Planning Application Ref: R/20/21/T

Location: St Peters & St Pauls Church, 77 The Street, Rustington, BN16 5NL

Description of works: To crown lift 1no. yew tree (*Taxus baccata*) to 2.5m above ground level. To crown lift 1no.lime (*Tilia*) tree to 3m above ground level. To remove all dead wood from 1no. strawberry tree (*Arbutus unedo*)

Figure 2 Positions of final cuts

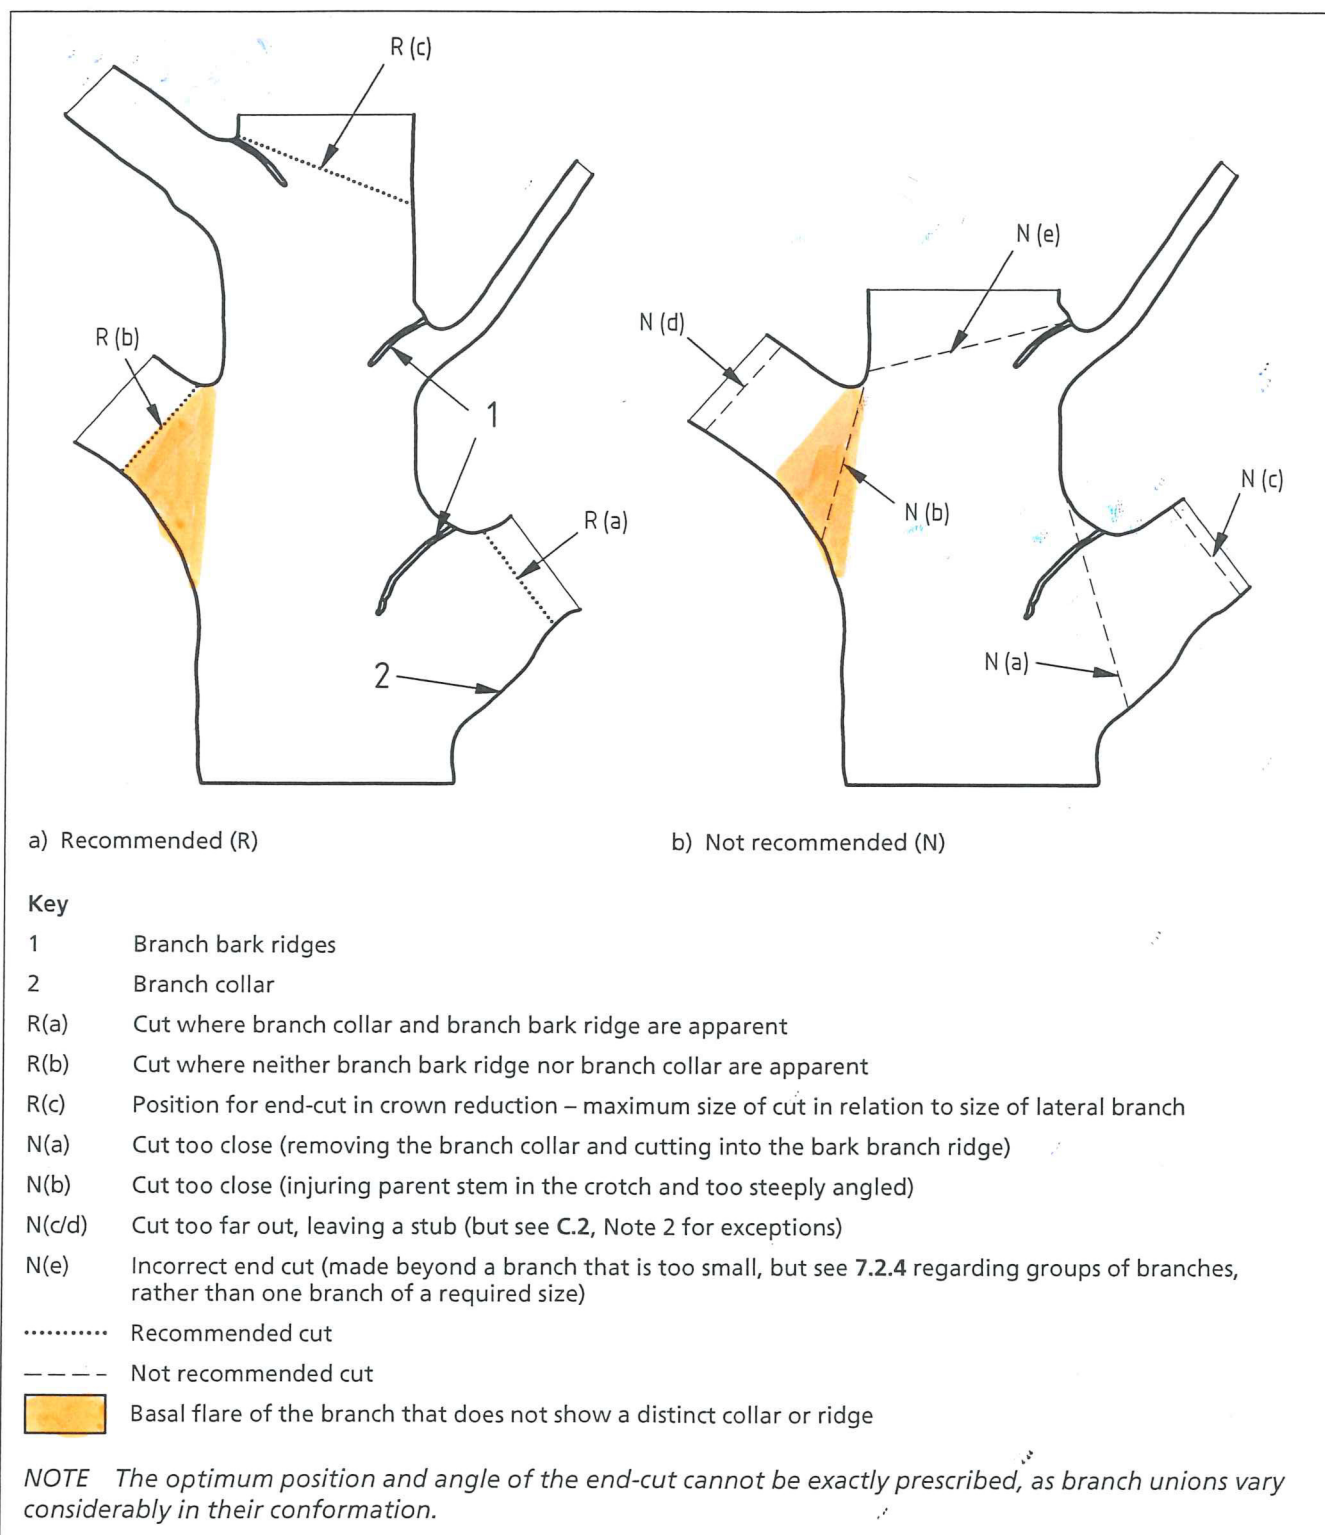
- Part a) Where whole branches are to be removed and final cuts made close to the trunk or branch union they are to be made as shown in Figure 2 of BS3998:2010
- Part b) Where branches are to be shortened back the final cuts are to be made at the correct angle shown in BS3998:2010 and adjacent to a live bud or lateral.
